## Oconee Flood Protection and the Jocassee Dam Hazard

NRC Meeting with Duke Energy Carolinas  
August 28, 2008

### **Random Dam Failure Frequency Issue**

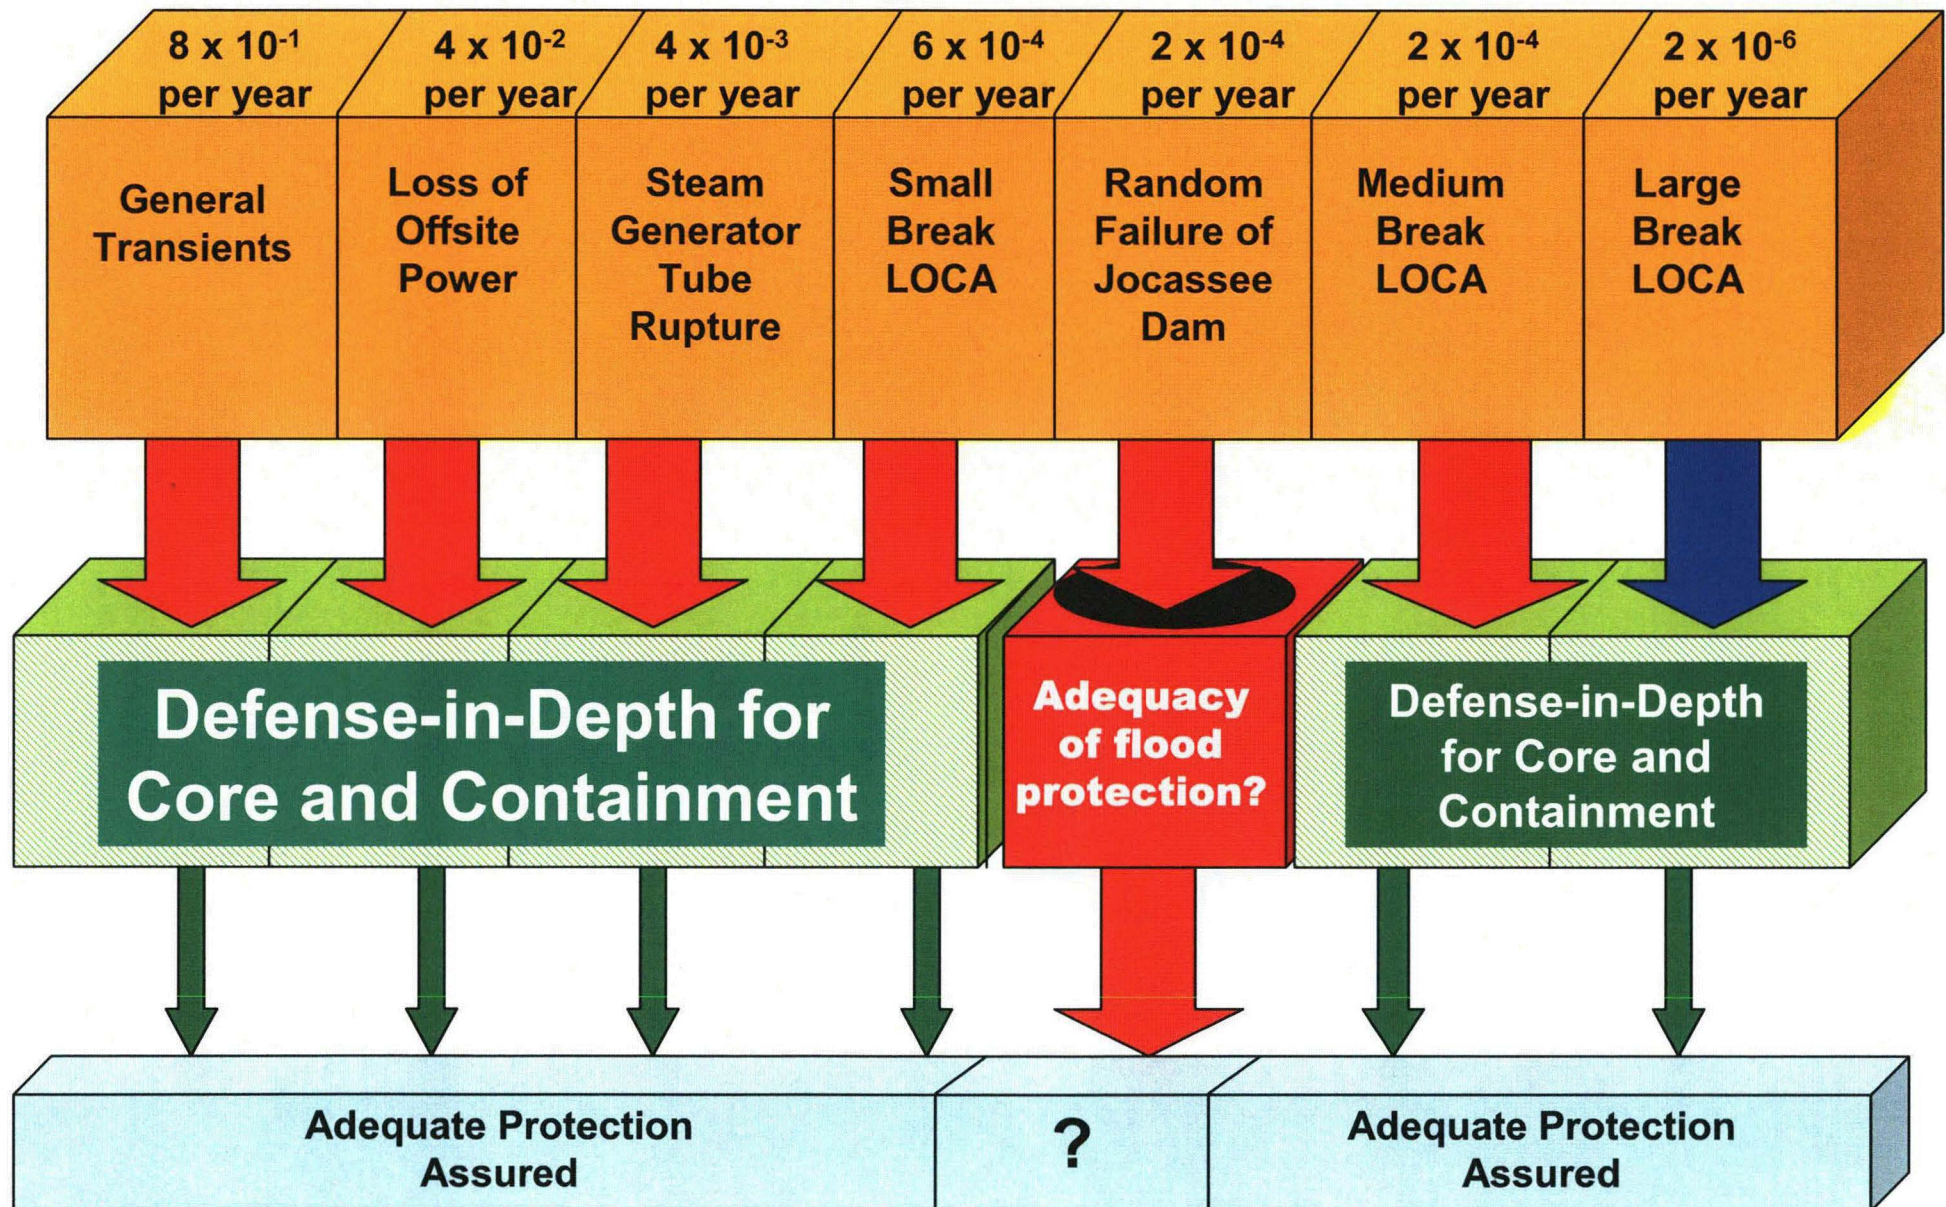
- NRC discovered an underestimate of random Jocassee Dam failure frequency as part of the Significance Determination Process (SDP).
- NRC communicated the underestimated random failure frequency to Duke in June, November, and December 2007.
